Interactive comment on “Diagnosis of future changes in hydrology for a Canadian Rocky Mountain headwater basin” by Xing Fang and John W. Pomeroy

Response to referee #1's comments:

Fig. 1. Figure 11. Simulated annual mean daily runoff for WRF CTRL and PGW. (a) Alpine, (b) treeline, (c) upper forest, (d) forest clearing blocks, (e) forest circular clearing north-facing, (f) forest circular

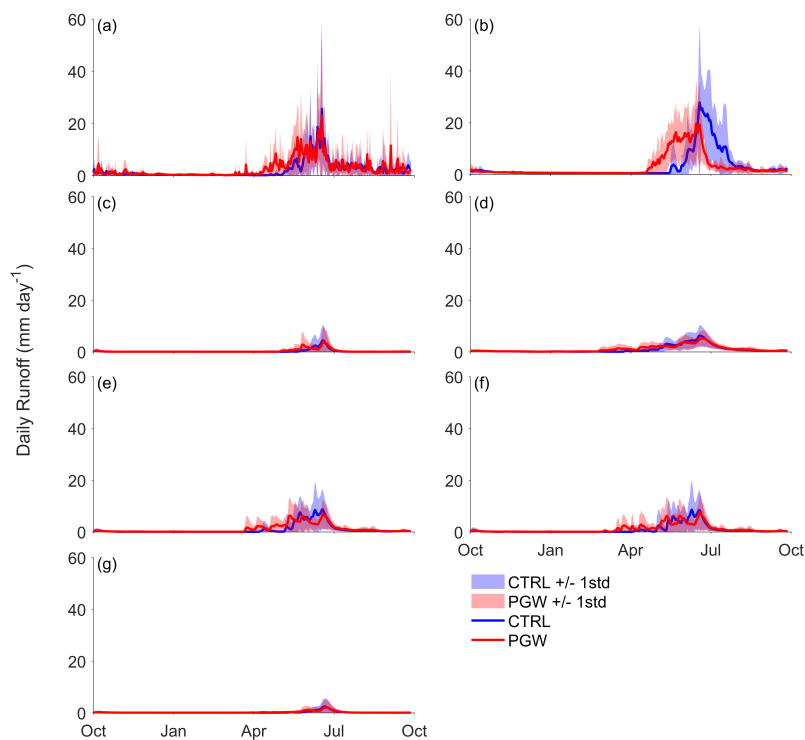
Detailed comment 23: Figure 11 and 12: The differences between the ecozones would appear clearer if you would use a uniform scaling of the y-axis. Response 23: We tried to have a uniform scaling of the y-axis for both Figs. 11 and 12, but the figures turned out showing the differences among the ecozones, but they are not great to show the differences between CTRL and PGW for some ecozones, particularly when their

values are small, e.g. Fig. 11c, d, g, and Fig. 12c, d, e, f, g. We included the changed figures with the uniform scaling of the y-axis below, so we think the original Figs 11 and 12 are probably better ones and will keep the original ones. We attached the changed Figs 11 and 12 with this response.
